Modification Report

MOD 2 Section 4.55(2) to modify
consent SSD-15788005

163 Barry Way, Jindabyne

PREPARED FOR NSW DEPARTMENT OF EDUCATION

FIGURE 21: BLOCK G EASTERN ELEVATION

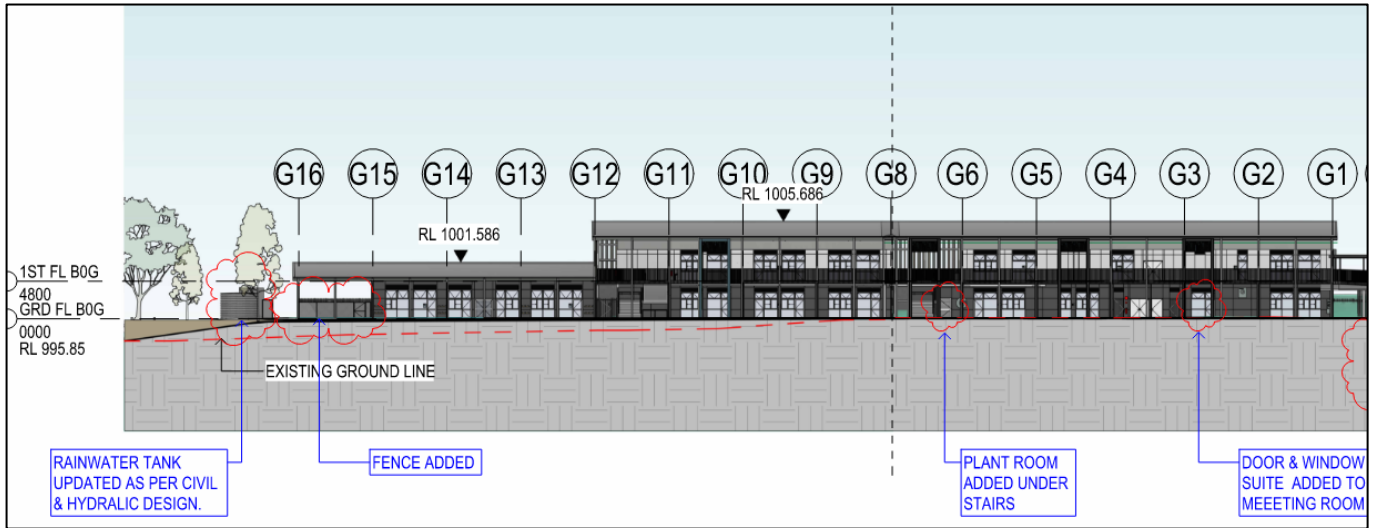
- New fencing along the western façade of Blocks G3 for greater access control.
- Addition of a door and window to the ground floor meeting room in Block G1 for improved functionality.
- Proposed plant room below the stairs in Block G.
- The workshop shed is to be moved to a more appropriate location.
- A new rainwater tank is proposed on the southern end of Block G to increase onsite water detention.
- Minor modifications have been made to the walkway facade between Blocks G and E integrating new screens.
- The ceiling height is proposed to be adjusted and minor amendments to sunshade detail are proposed as a result of detailed design considerations.

- Internal layout amendments to the kitchen preparation and store room, and the wood and metal work store rooms.

FIGURE 26: UPDATED SITE INFRASTRUCTURE LAYOUT

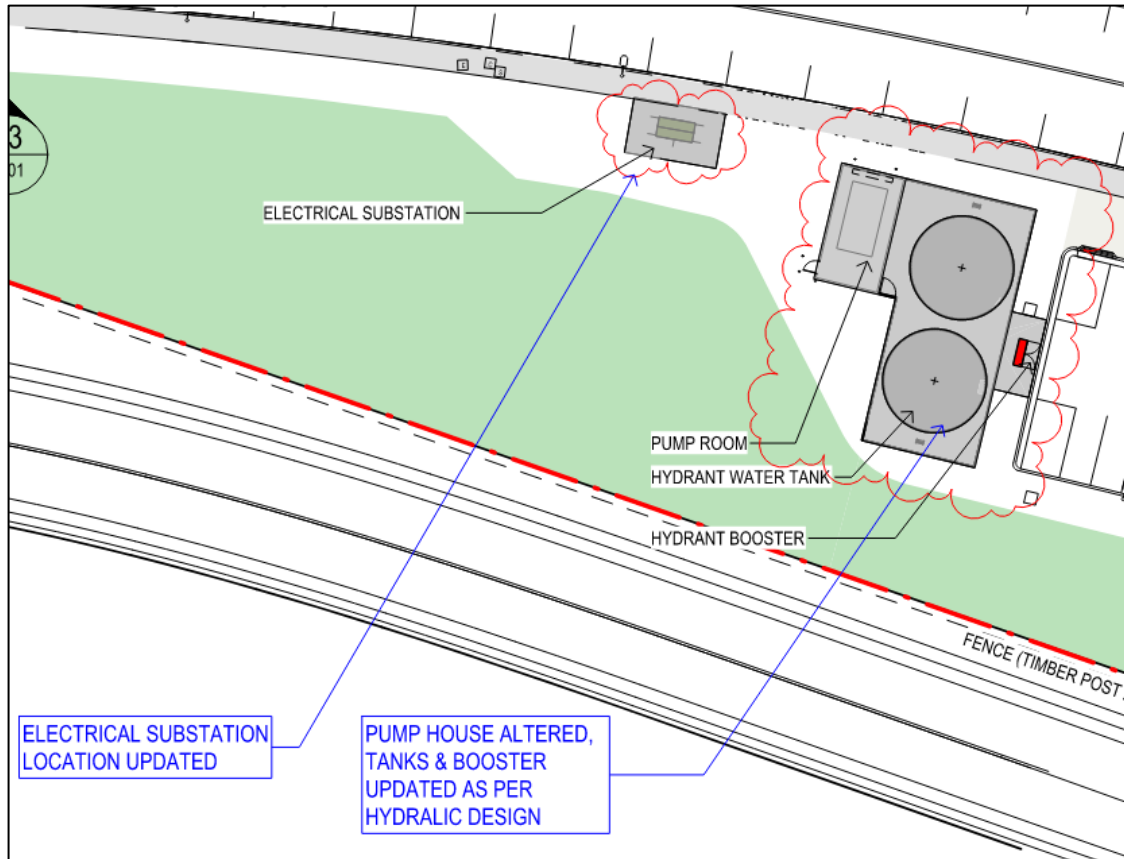
- The pump house is proposed to be relocated to better accommodate the hydraulic design requirements, and fencing around the pump house is proposed for access control and safety.

- The booster's location is proposed to be amended as part of the updates to the hydraulic design.
- Accompanying the pump house changes, the water tanks have also been shifted closer to the car park.
- Fencing is proposed around the LPG tank storage area for access control and safety.

FIGURE 28: PROPOSED LANDSCAPE PLAN

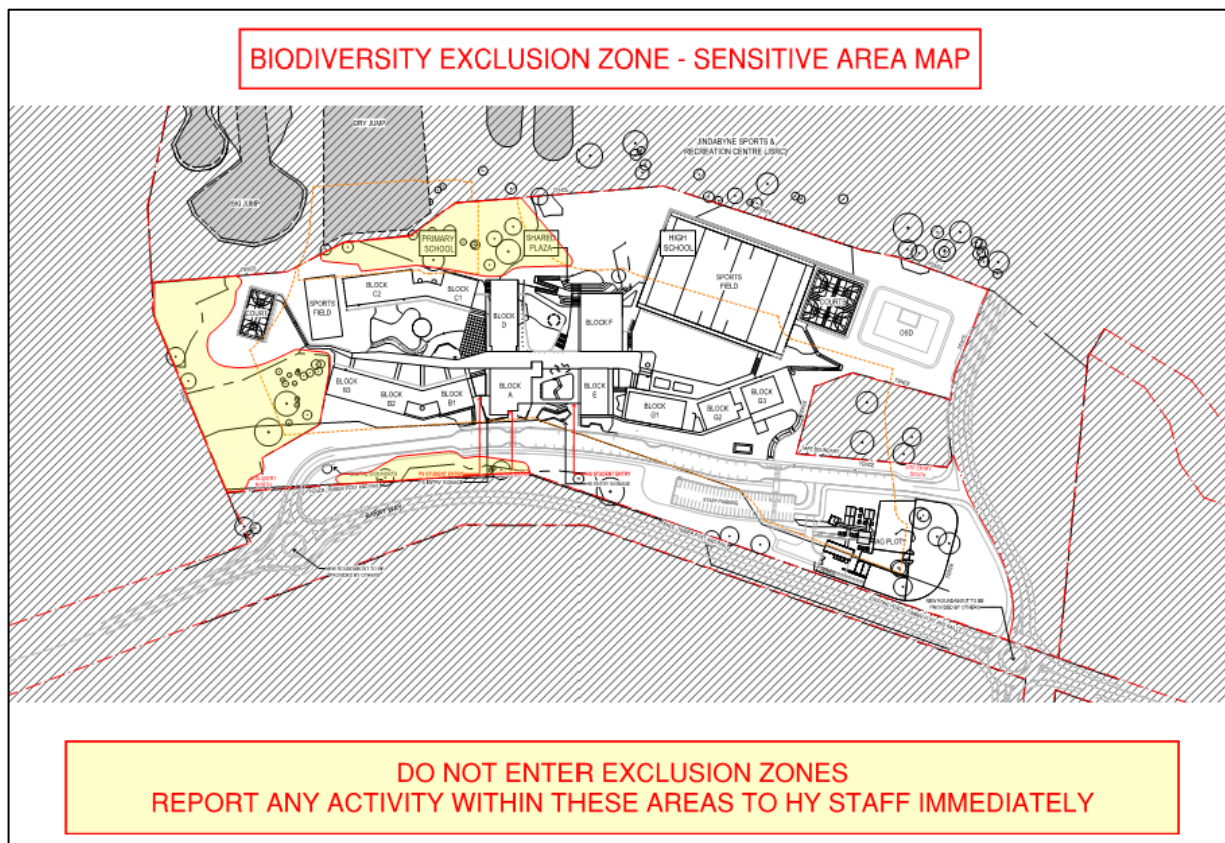
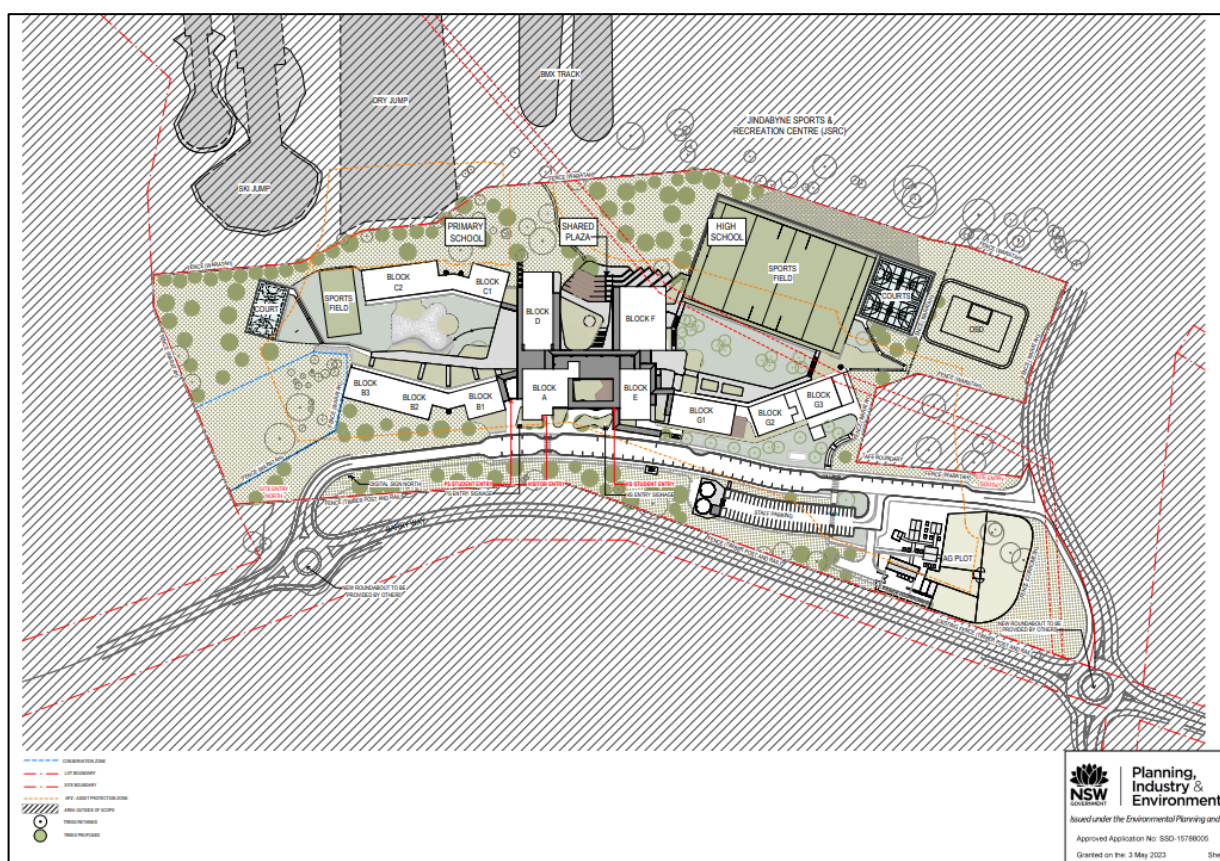
- the various amendments relating to open space design and fencing, and
- to exclude any works from the “biodiversity exclusion zones” nominated as part of the Biodiversity Management Sub-Plan prepared by WSP in accordance with Condition B21 of the consent for SSD-15788005.

The total number of native trees to be retained (105 trees) and removed (105 trees) is unchanged from SSD-15788005 as modified and 190 trees are proposed to be planted. Refer to the updated landscape plans attached at **Appendix 3** for further detail. All the trees previously proposed to be planted in the BEZs are now located within other areas of the site.

FIGURE 30: SEDIMENT AND EROSION CONTROL PLAN
Source: Northrop

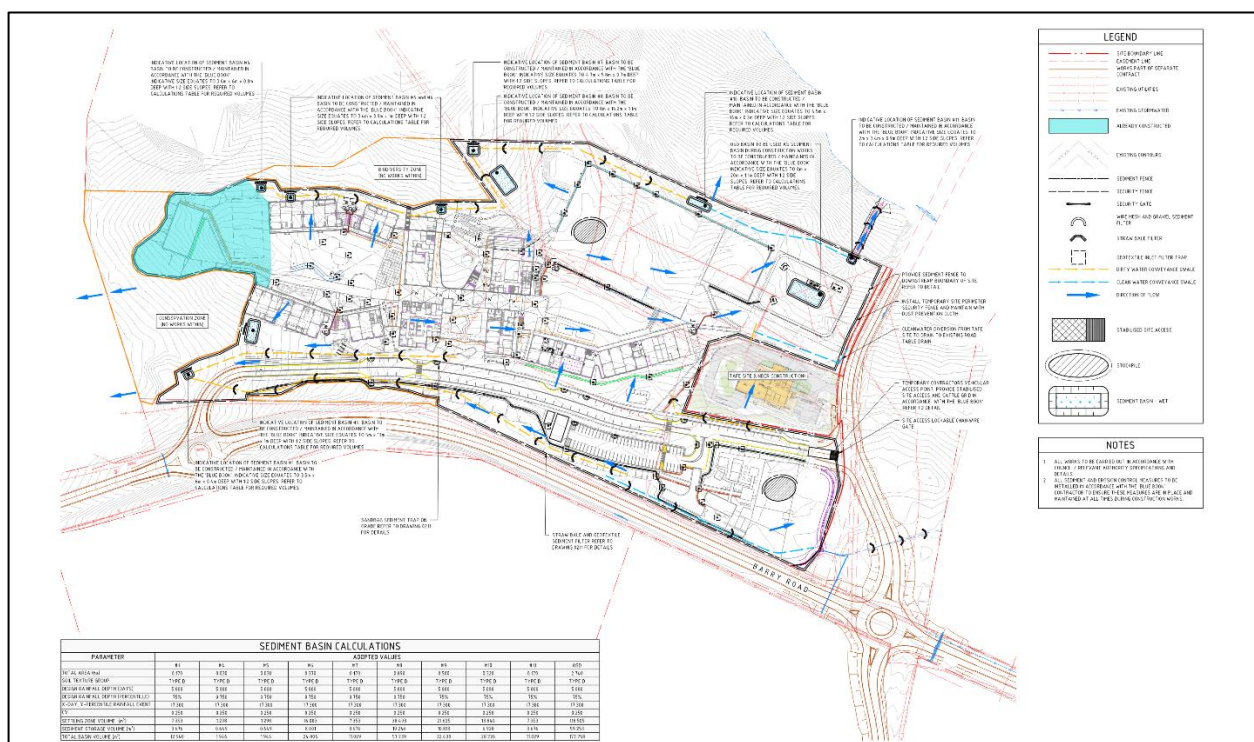
Erosion and sediment control measures change as the project progresses due to evolving site conditions. The erosion and sediment control plan submitted with MOD 1 has been updated in the amended civil plan set to reflect amended necessary works for site areas that now contain completed structures which remove the need for erosion and sediment control measures for these areas. The updated Sediment and Erosion Control Plan and associated details have been provided within the Civil drawing at **Appendix 2**.

An extract of the updated Sediment and Erosion Control Plan is provided below. Subject to implementing the required sediment and erosion control measures during construction, there will be no unacceptable environmental impacts with regard to soil and water management.
